Re: 230434 – Wallaroo Solar Farm

Appendix A - Response to item 1 – Planting Density

Appendix B Response to item 2 - Jarramlee Reserve buffer

Appendix C Response to item 3 – BESS locations

Visual Impact Assessment Photomontages PM02

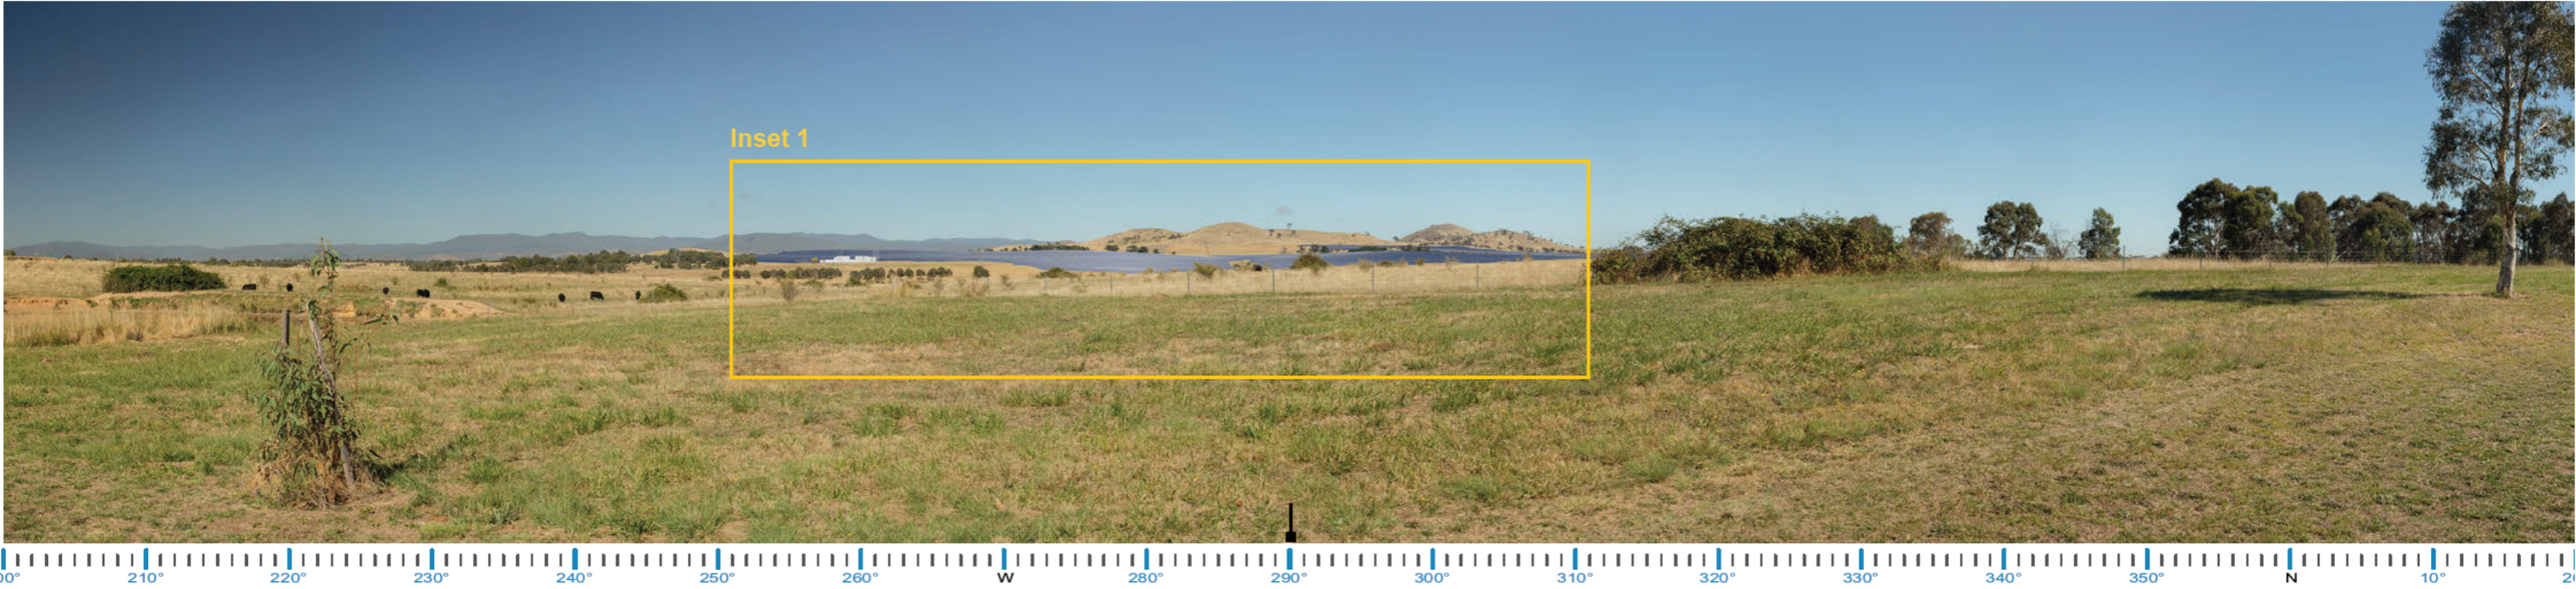
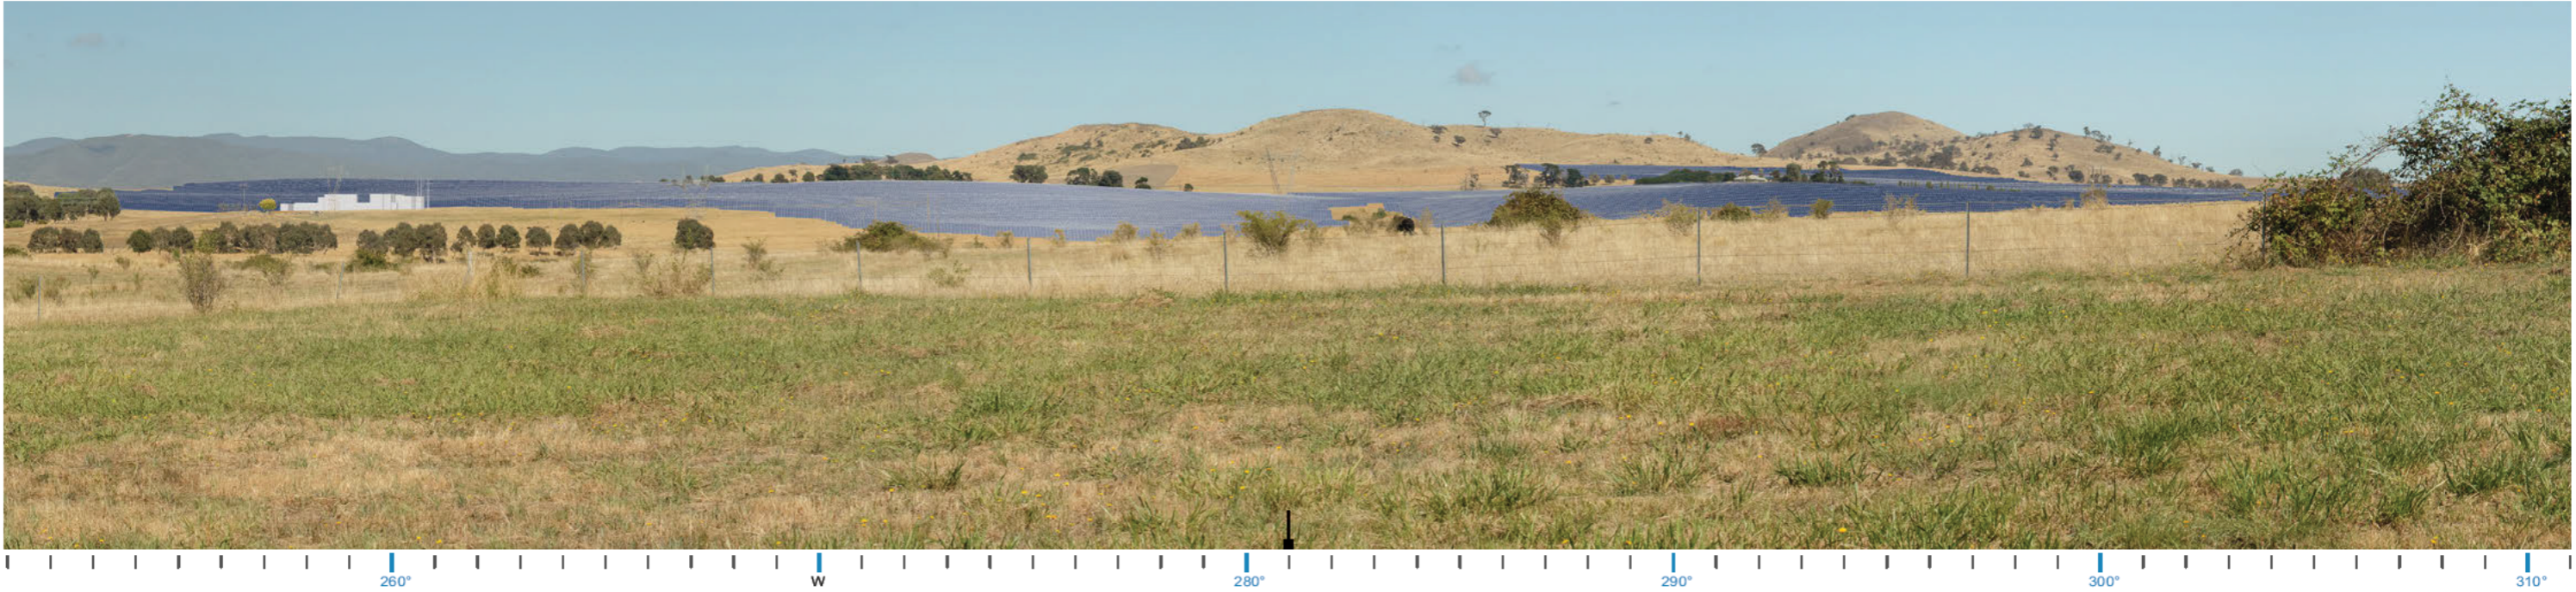
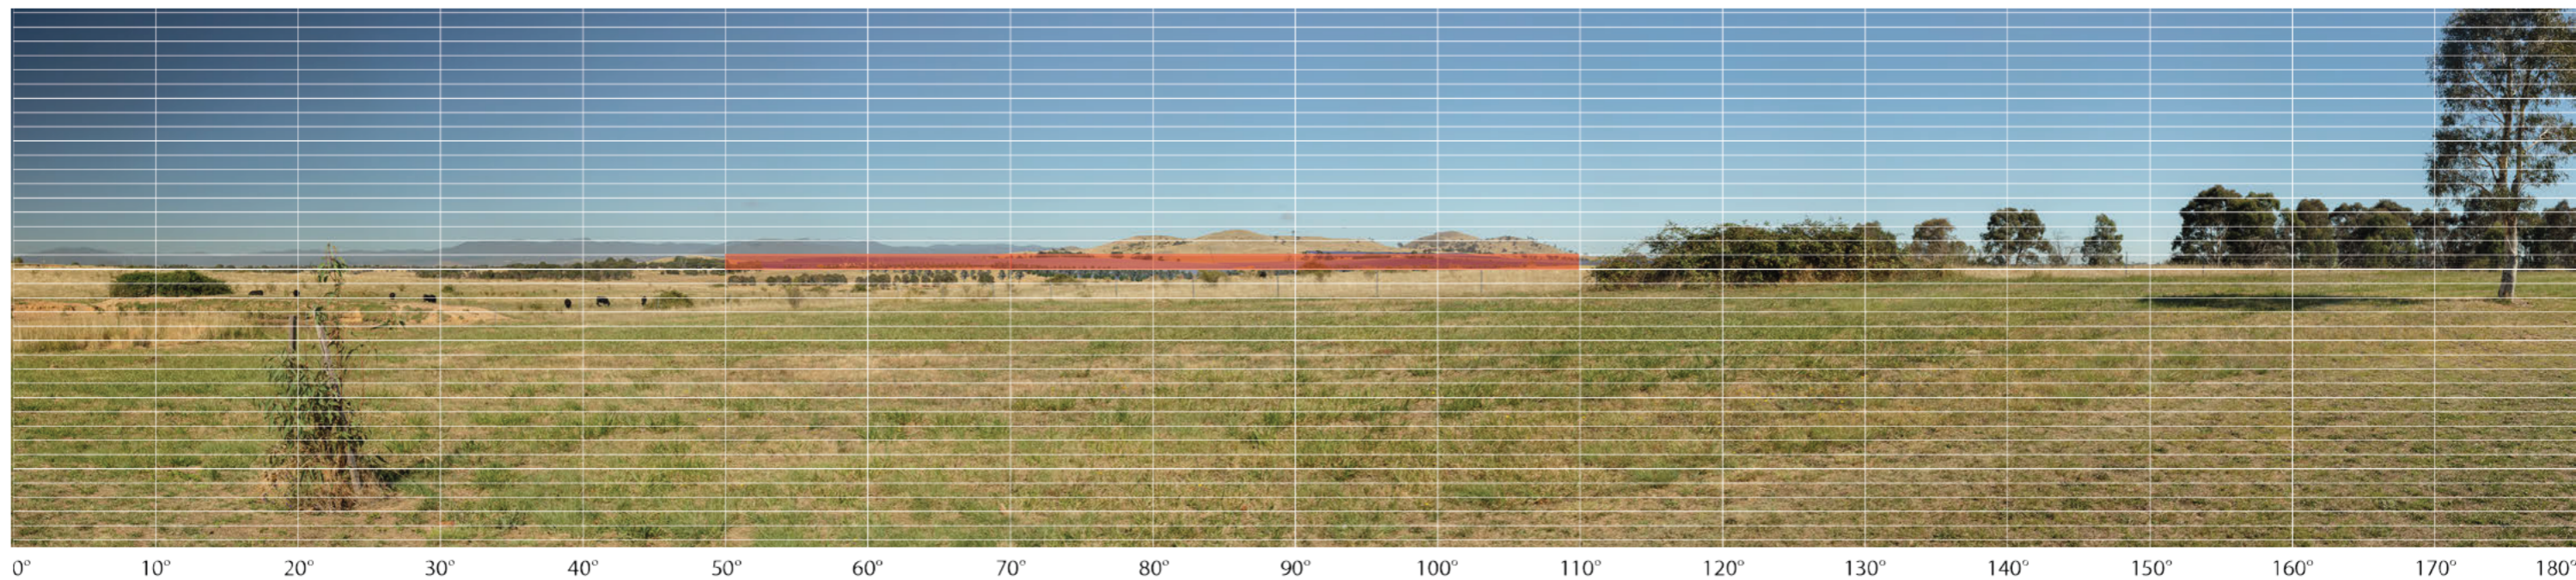
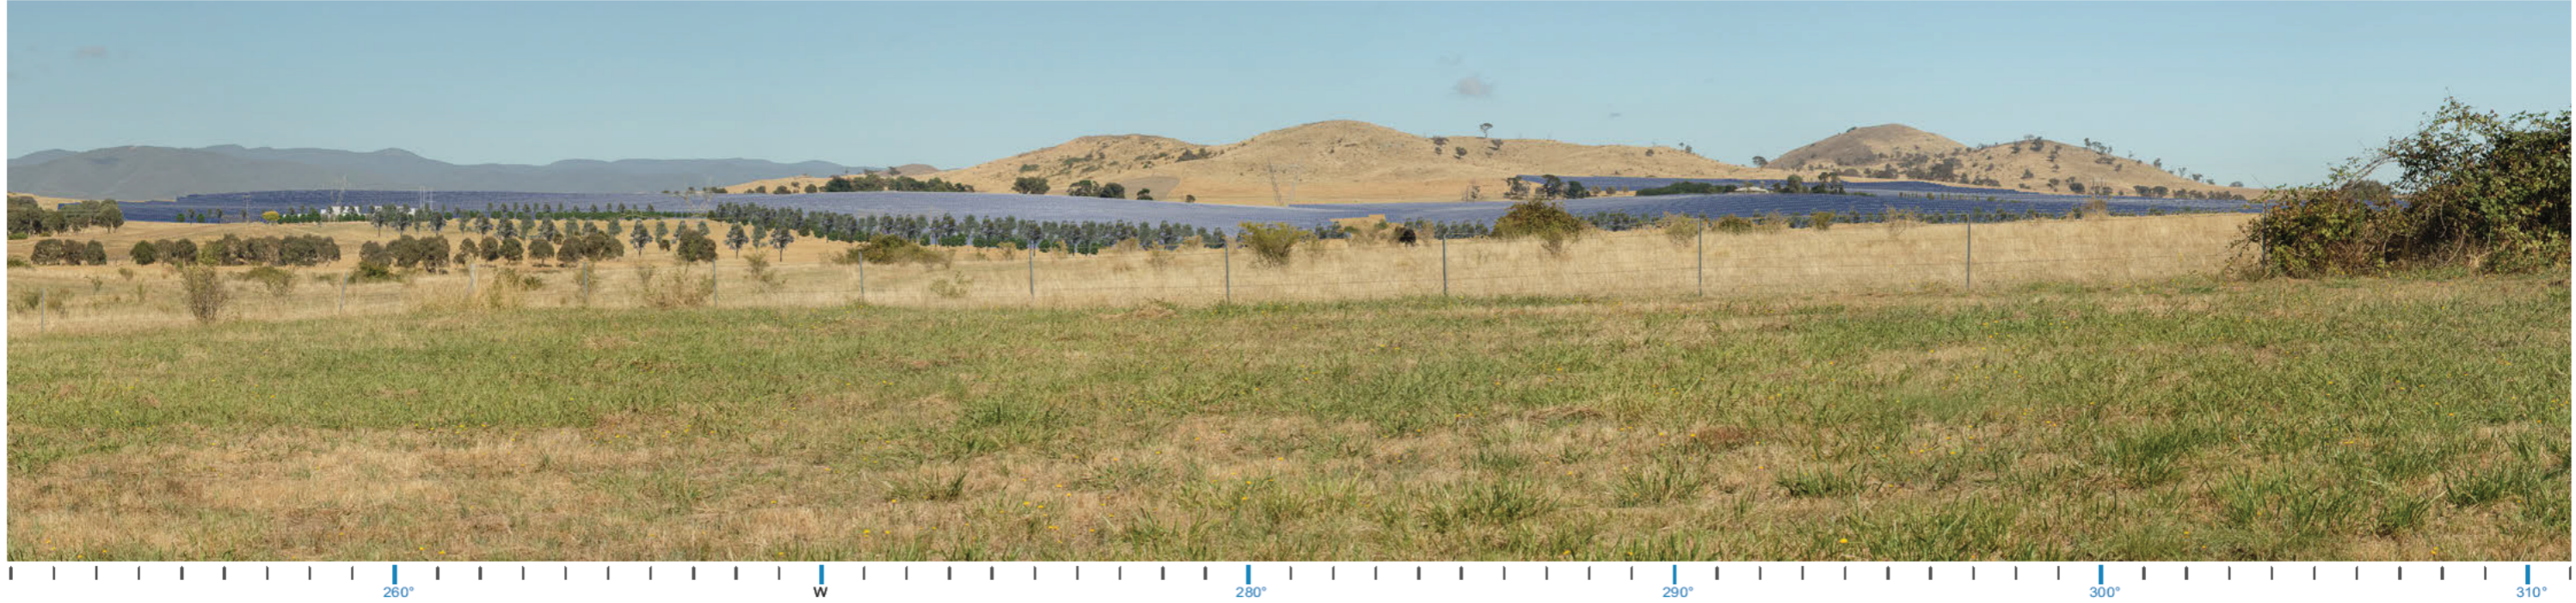
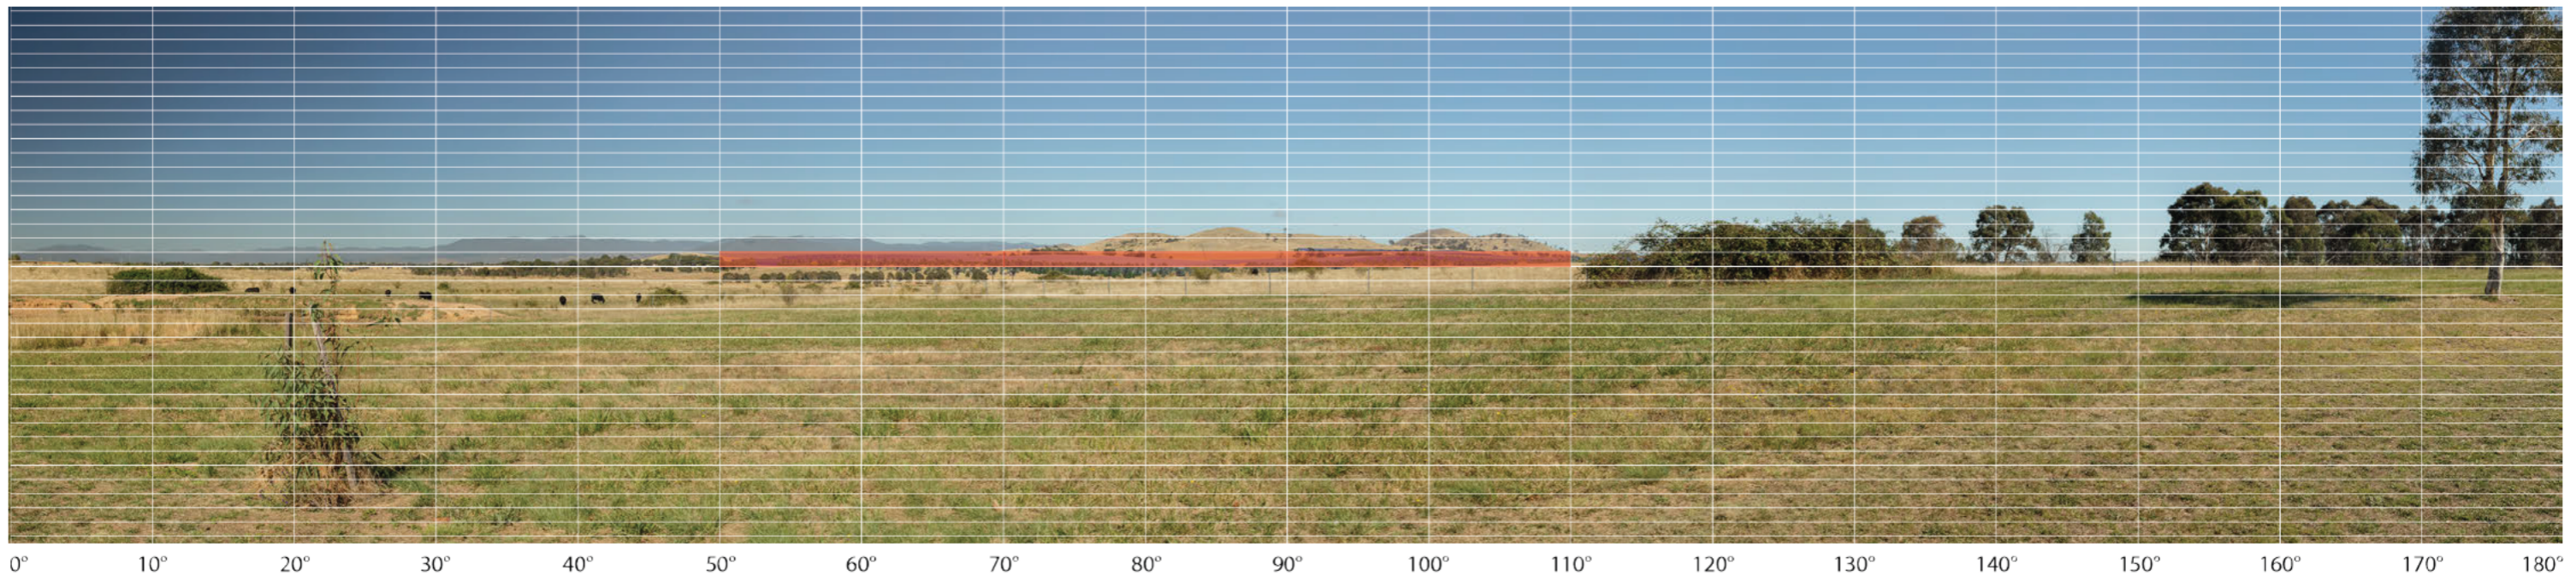
1. The IPC raised concerns about the density of planting from the PM02 photo point in the Visual Impact Assessment
2. The IPC requested confirmation that there is a 10m buffer from the Jarramlee Reserve and the Development footprint
3. The IPC asked if the indicative locations of the BESS can be shown in a map

Following the recommendations of the IPC and the DPPI, denser planting along specific areas along the eastern boundary of the Project have the potential to further fragment views from this location.

Denser planting can be achieved by increasing the quantity of proposed tree and shrub species and decreasing the gap between canopies. The dense vegetation plantings are an existing element in the landscape and are particularly evident along fence lines, boundary vegetation associated with dwellings as well as wind break vegetation, refer **Image 01** and **Image 02**. Therefore, the proposed dense planting assemblages are in keeping with the existing vegetation character of the broader landscape which is visible as roadside vegetation, windbreak, or boundary vegetation (see character images).
